# Technical Service Information

## FORD AX4S (AXODE) INTERMITTENT NEUTRAL COMING TO STOP

Figure 1

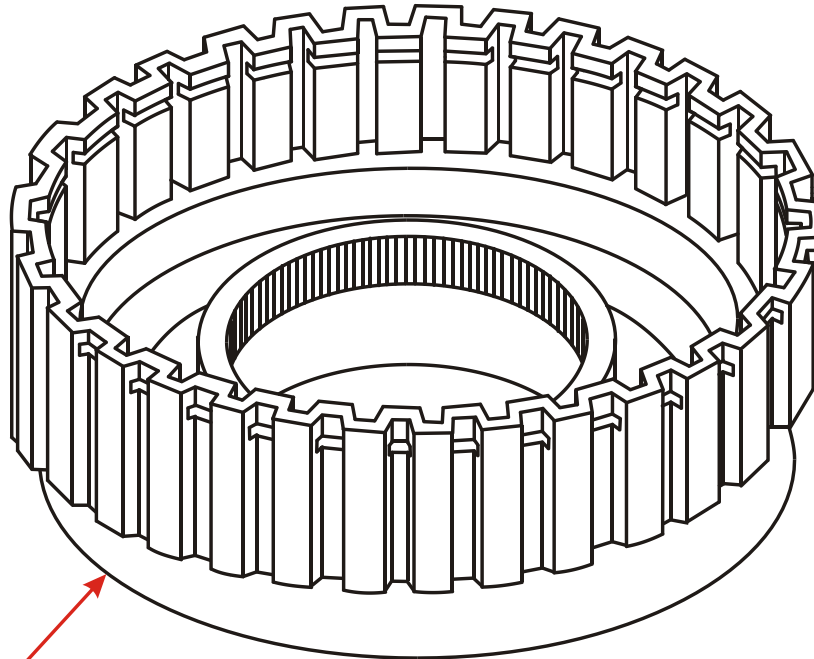
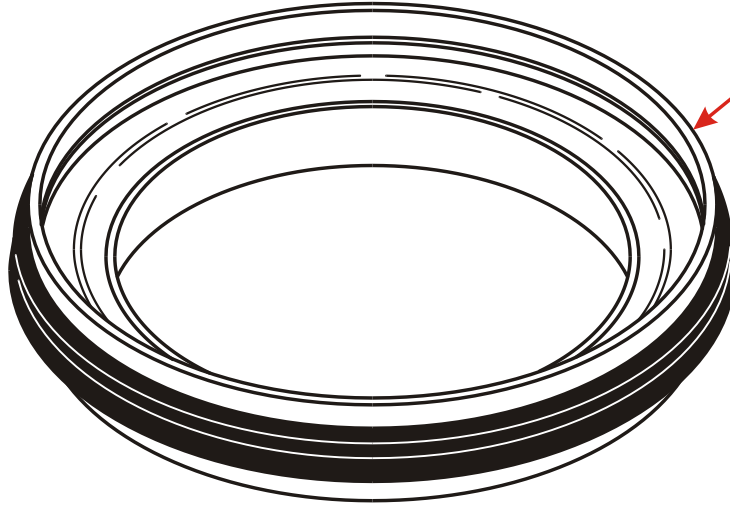
**CAUSE:** The cause may be, the molded rubber seal on the forward clutch piston intermittently not sealing during the 3-2 downshift (See Figure 1).

**CORRECTION:** Replace the forward clutch piston *and* the forward clutch cylinder with the OEM part numbers listed below. Refer to Figure 1.

**FORWARD CLUTCH  
MOLDED PISTON  
F8DZ-7A262-AB**

**FORWARD CLUTCH CYLINDER  
F5DZ-7A360-A**
